NPF-38-08

DESCRIPTION AND SAFETY ANALYSIS  
OF PROPOSED CHANGE NPF-38-08

This is a request to modify the Technical Specifications to remove the Core Protection Calculator (CPC) Type I and Type II Addressable Constants, as approved by the NRC Core Performance Branch in April, 1985.

FIGURE 3.2-3

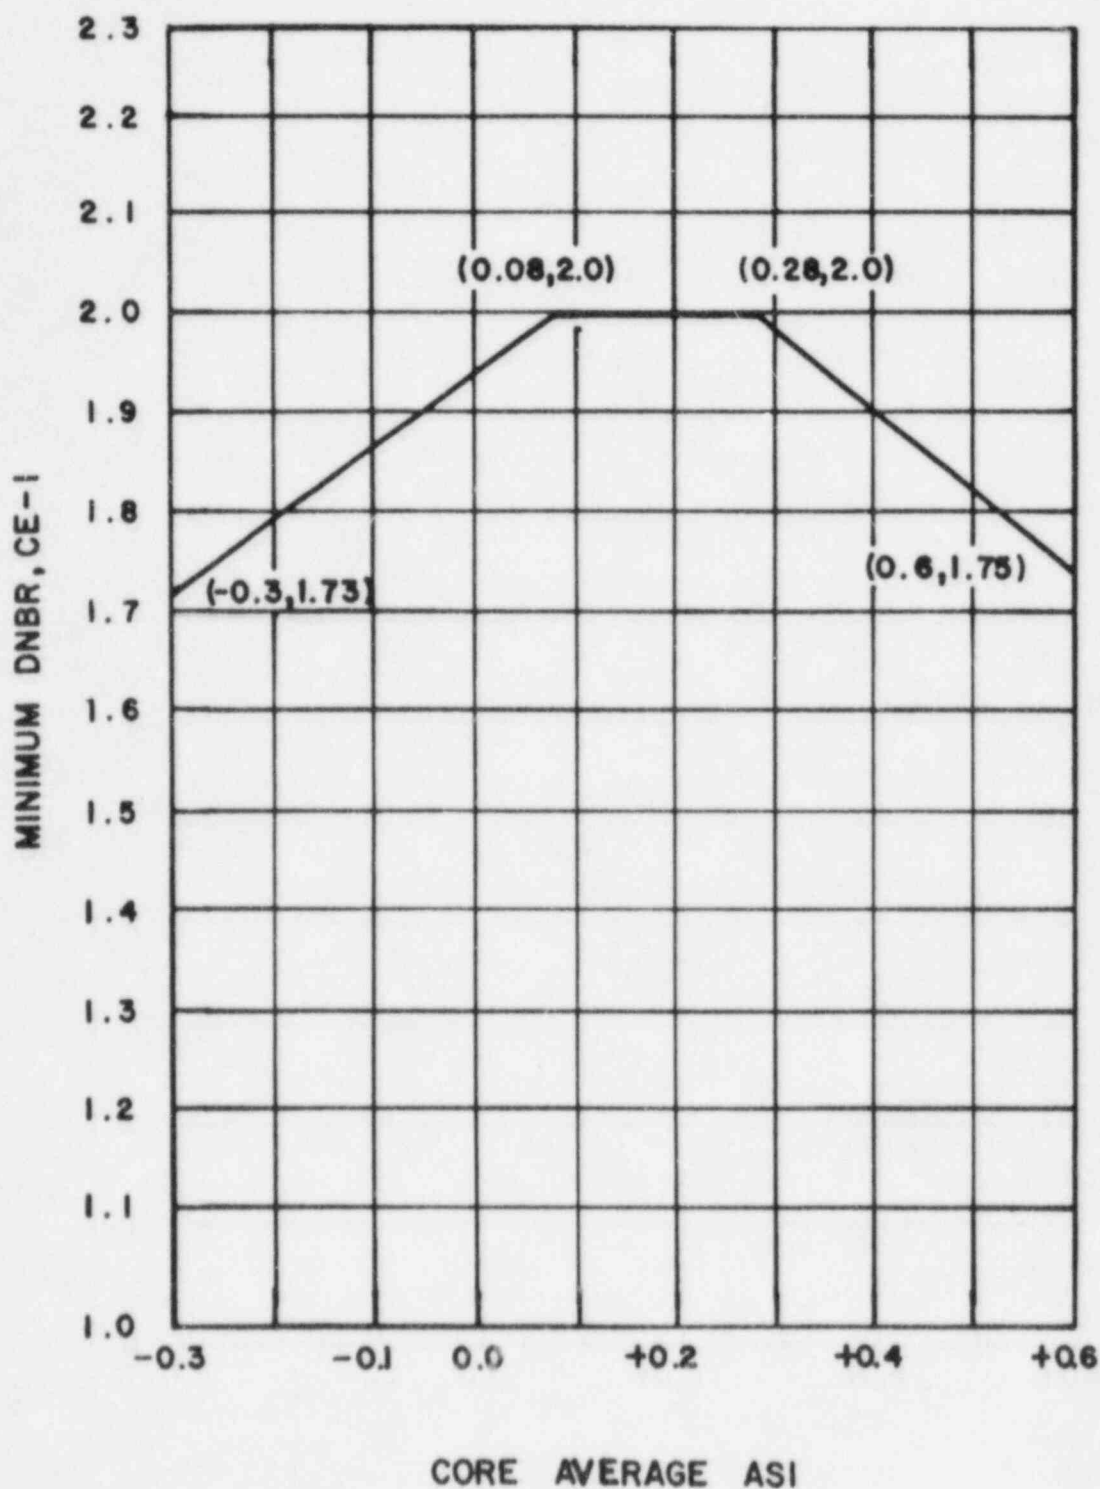
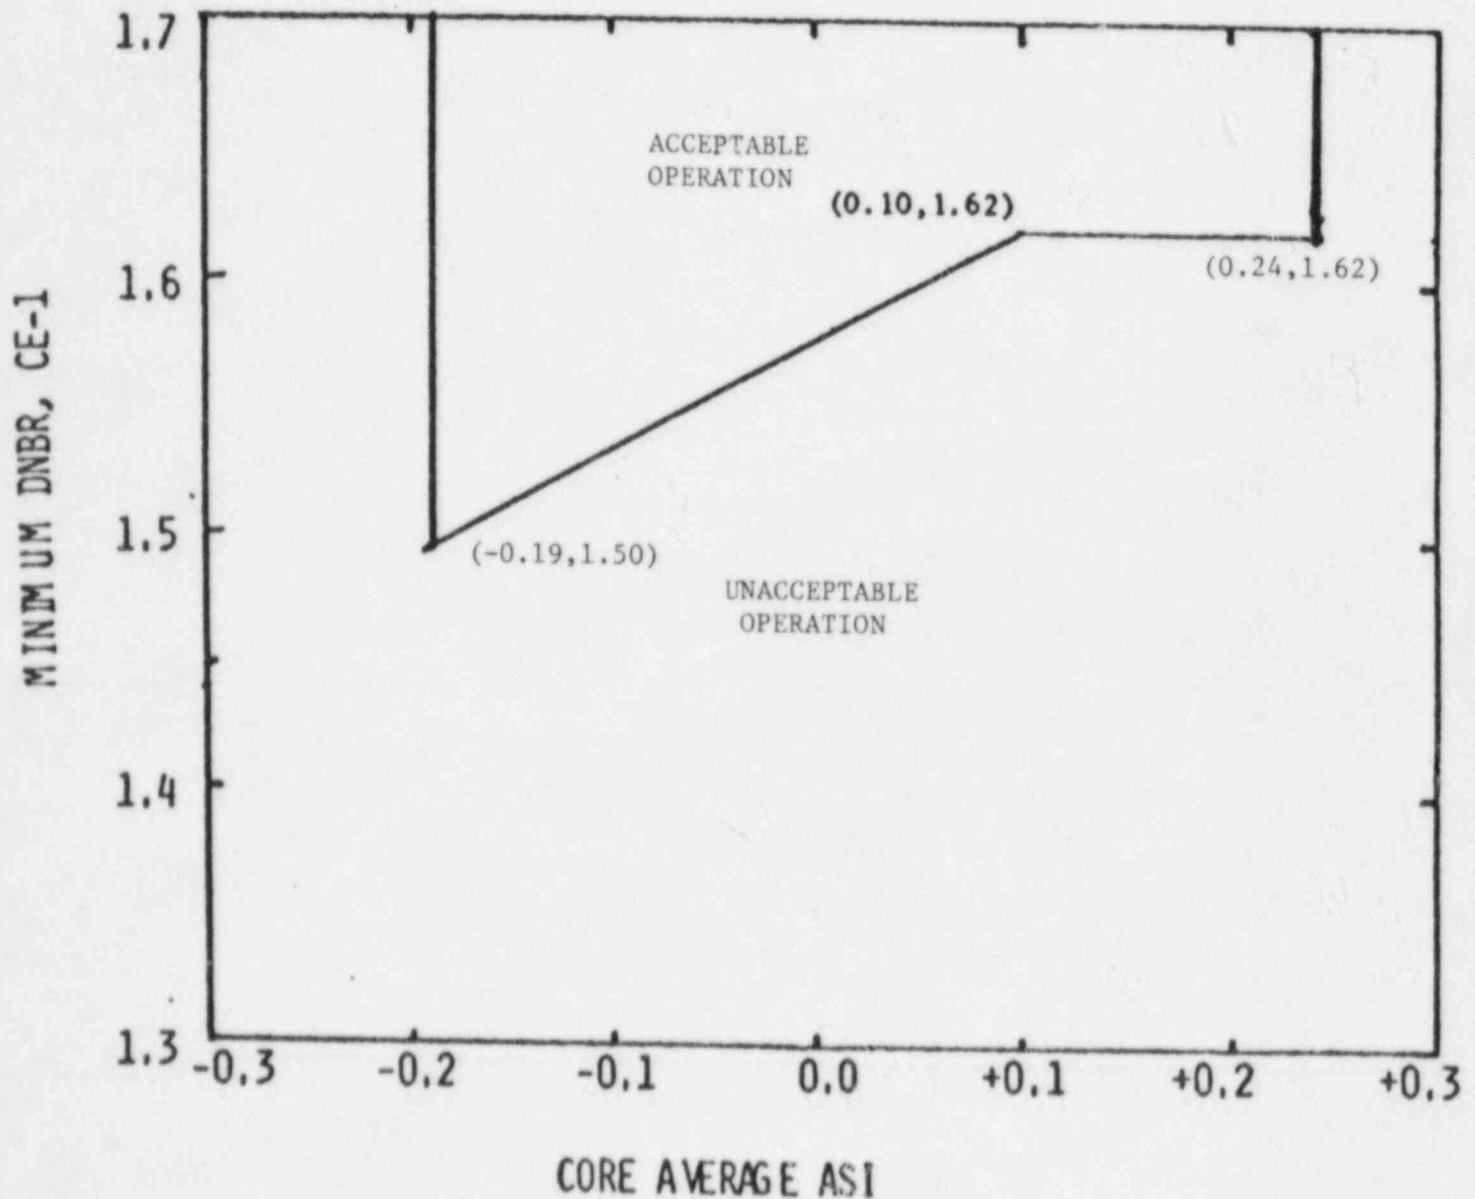
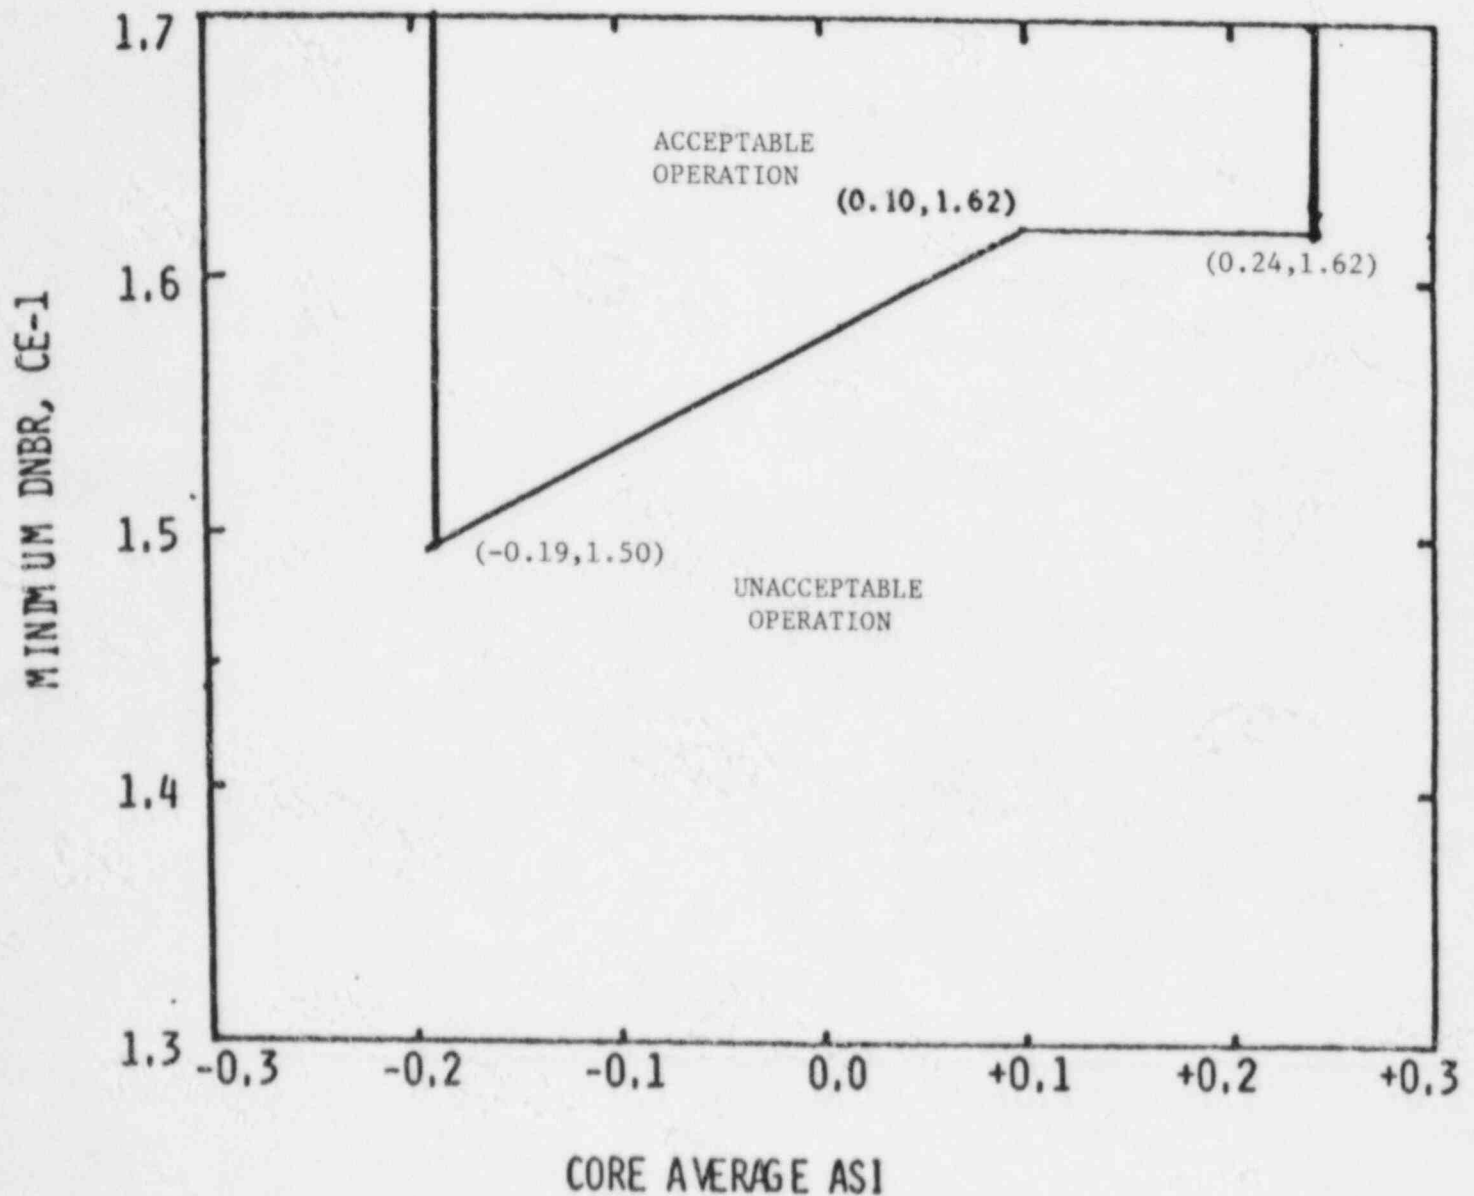
In this case the proposed change described above is similar to Example (vi) in that revising Technical Specifications 3.2.1, 3.2.4 and 3.2.7; revising Figure 3.2.3 and Action 6.6.1 of Table 3.3-1; replacing Figure 3.2-2; and revising the associated Bases is clearly within all acceptable criteria specified by the NRC for digital plant protection systems in general and the CPC in particular. Additionally, the changes provide for less impact than allowed by Example (vi) because no safety margins are reduced.

Parameters required to maintain the margin to DNB and total core power are also monitored by the CPCs. Therefore, in the event that the COLSS is not being used, operation within the limits of Figure 3.2-3 can be maintained by utilizing a predetermined DNBR as a function of AXIAL SHAPE INDEX and by monitoring the CPC trip channels. The above listed uncertainty and penalty factors plus those associated with startup test acceptance criteria are also included in the CPCs which assume a minimum core power of 20% of RATED THERMAL POWER. The 20% RATED THERMAL POWER threshold is due to the neutron flux detector system being inaccurate below 20% core power. Core noise level at low power is too large to obtain usable detector readings.
